TO: Mills City Council
FROM: Megan Nelms, AICP, City Planner
DATE: February 25, 2025
SUBJECT: Vision Beyond Borders – Development Plan

Case Number: 24.04 DEV

**Vision Beyond Borders
Commercial Development Plan**

LIGHTING PLAN
VISION BEYOND BORDERS
MILLS, WY

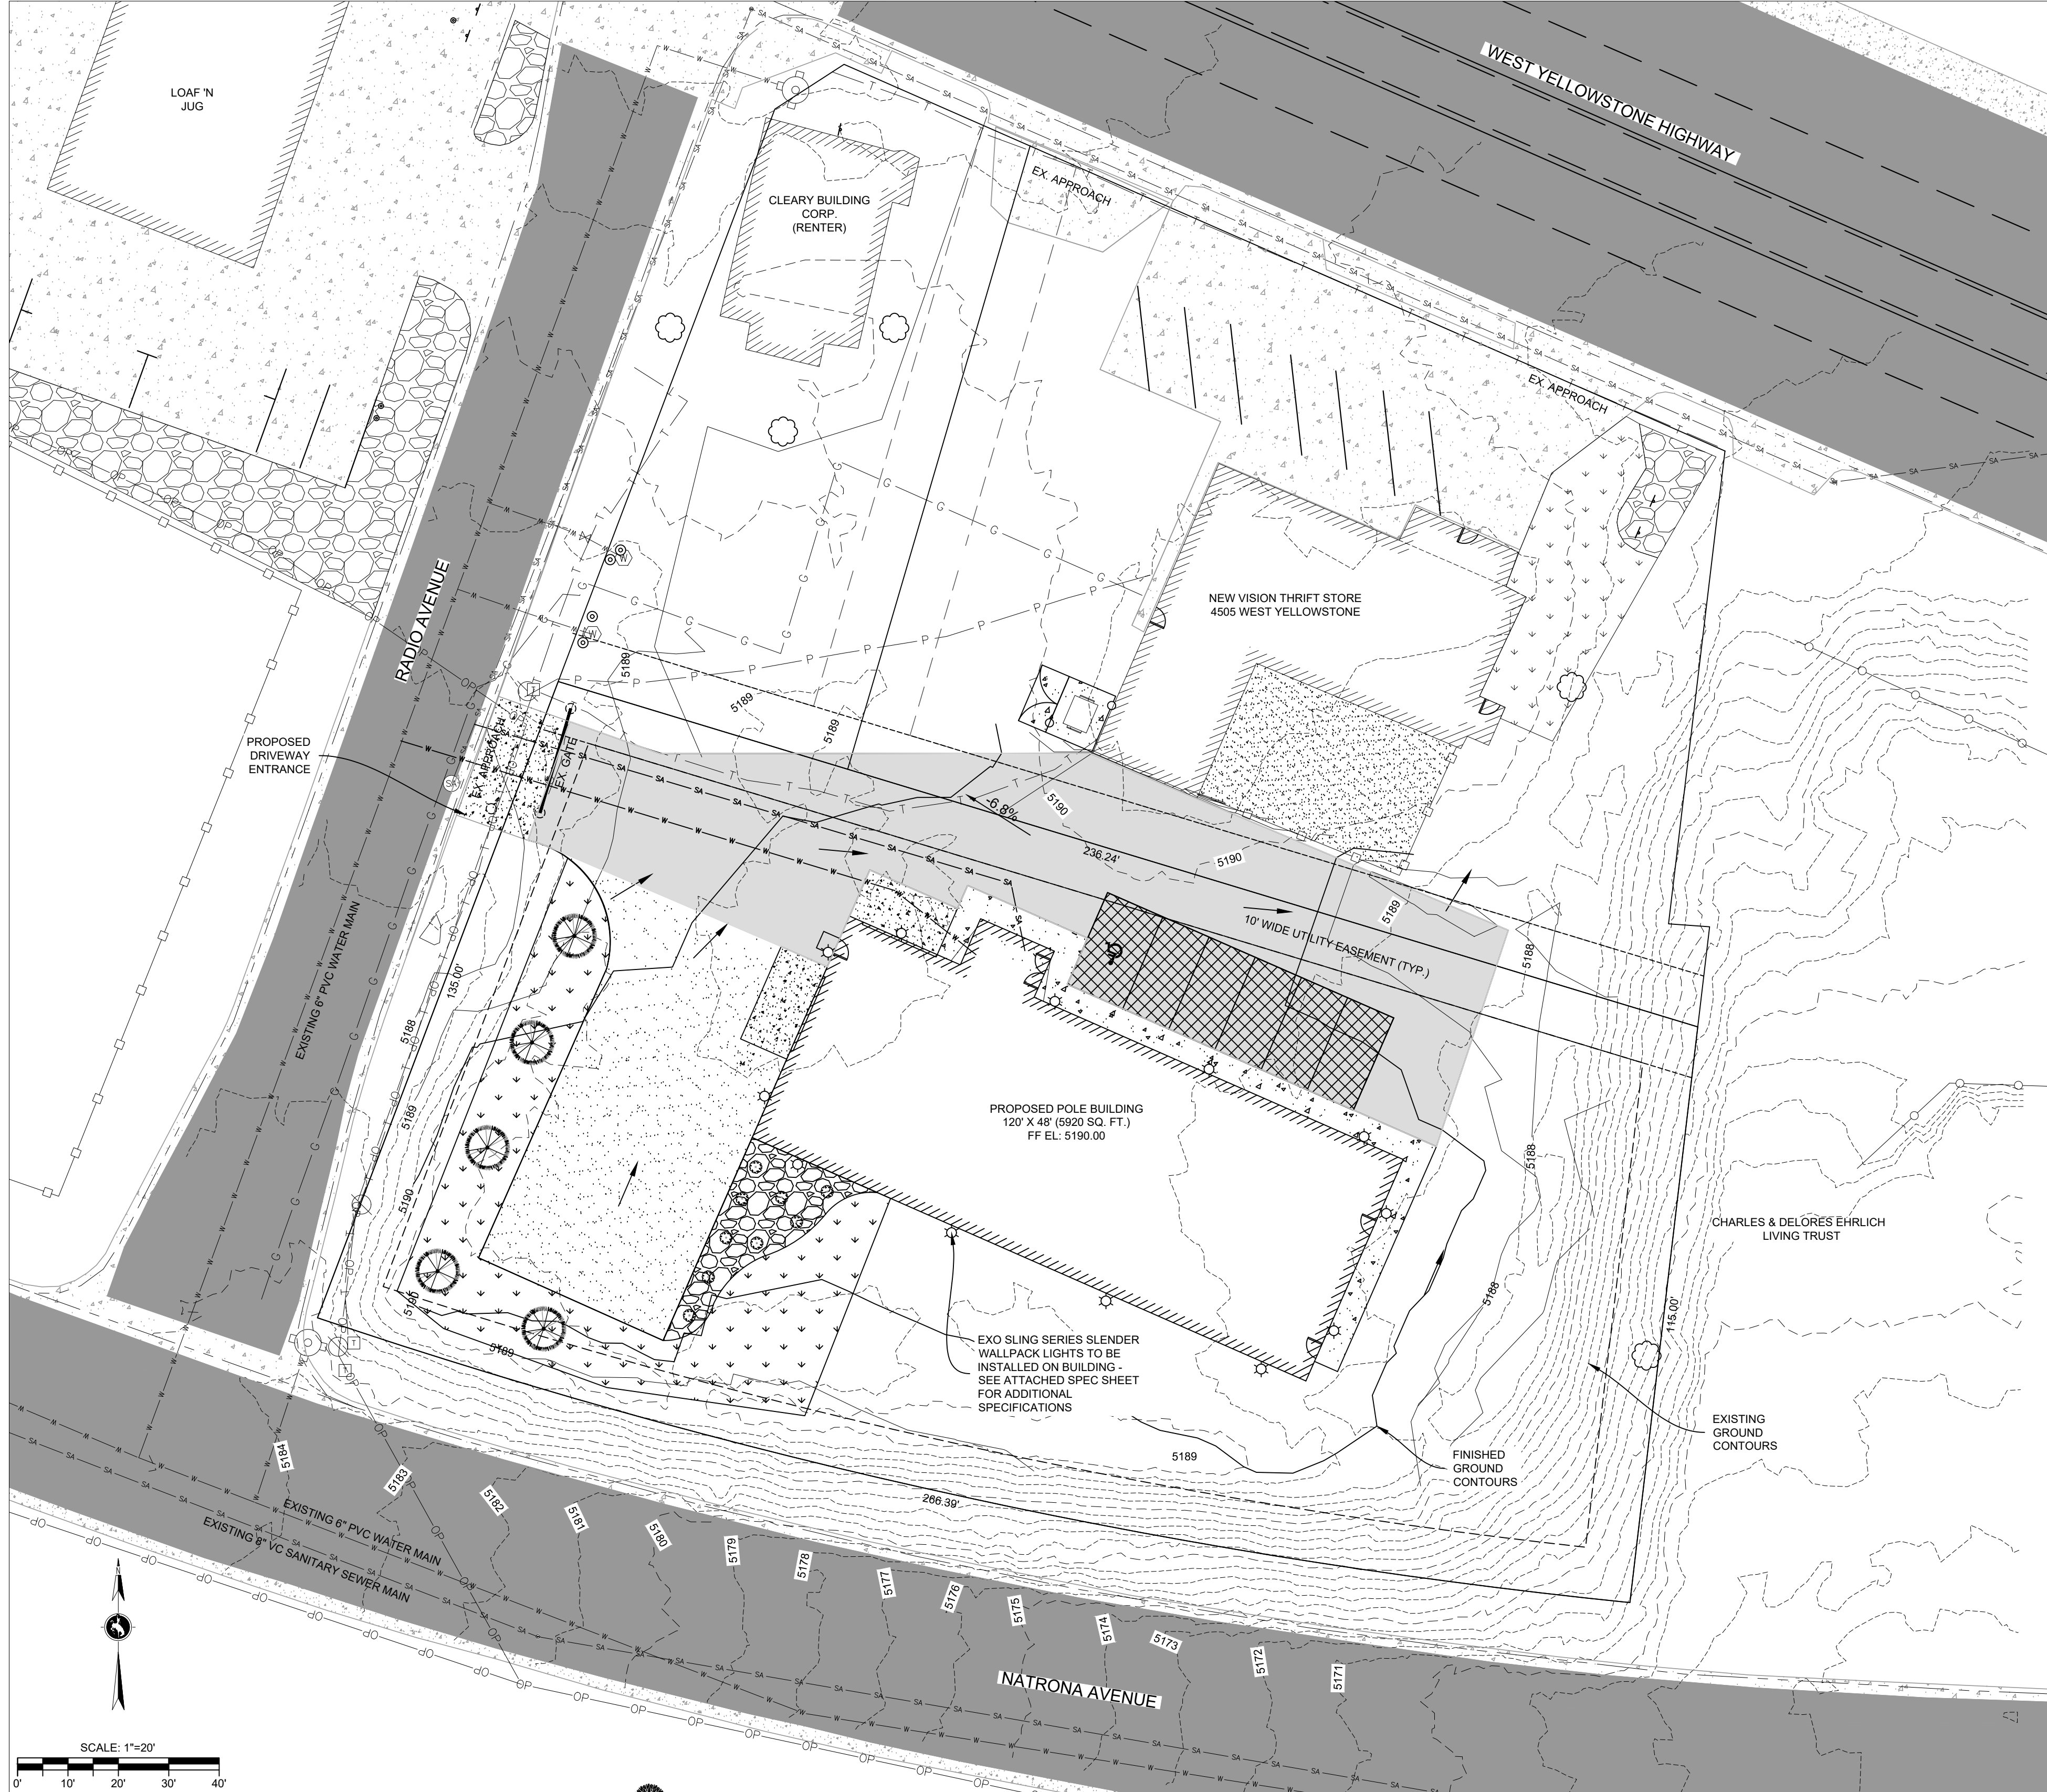
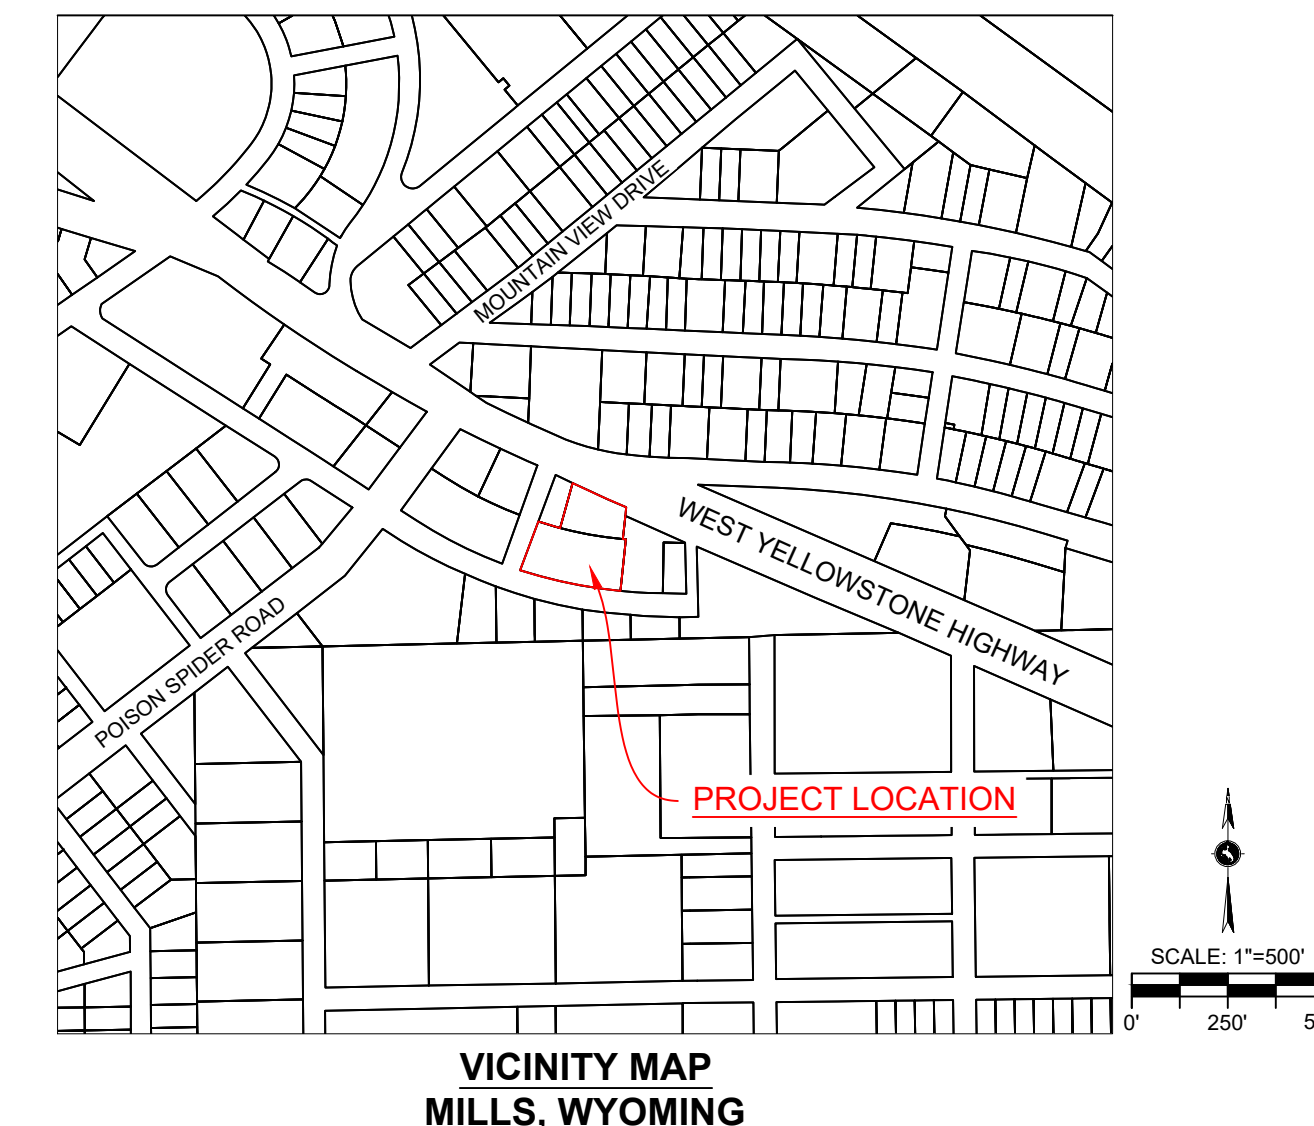
1. The previous application contained a conceptual exterior lighting plan. A more detailed exterior lighting plan has been provided with this submittal and appears to be in conformance with the LDRs.

- a. No parking lot lighting is proposed
 - b. Exterior lighting will be limited to the building with shielded wall-packs. The applicant needs to specify which model of the Sling Series Slender Wallpack light will be utilized.
